VKMA 01250

Tehnički bilten – studeni 2011.

AUDI, FORD, SEAT, SKODA, VW

Promjena sadržaja kompleta: 2 dodatna usadna vijka u kompletu

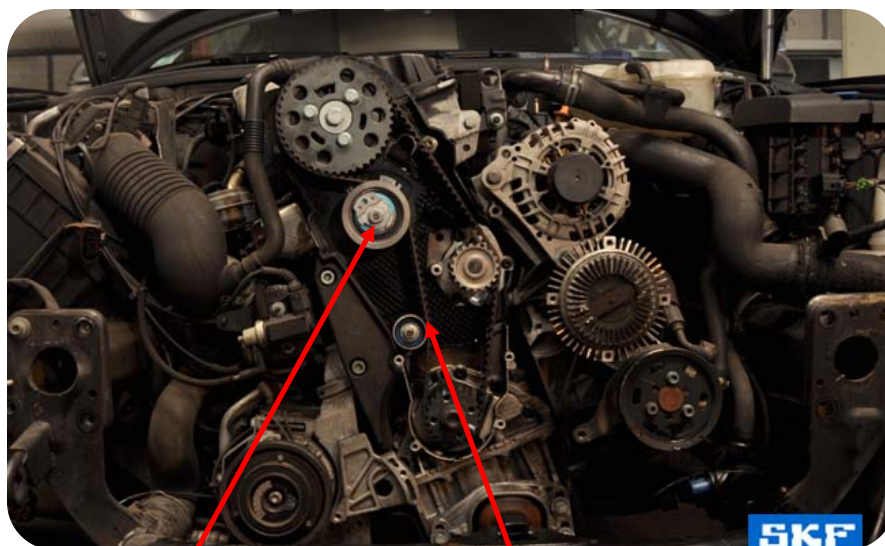
2 nova usadna vijka u kompletu VKMA 01250:

OE # N 909 055 02
Montaža na VKM 11250

OE # N 104 447 02
Montaža na VKM 21147

VKM 11250
+ 1 zatik, 1 vijak i 1 matica.

VKM 21147
+ 1 vijak i 1 matica.

Zatezni moment:
- matica (16): 20 Nm + kut
pritezanja od 45°.
- matica (19): 20Nm.
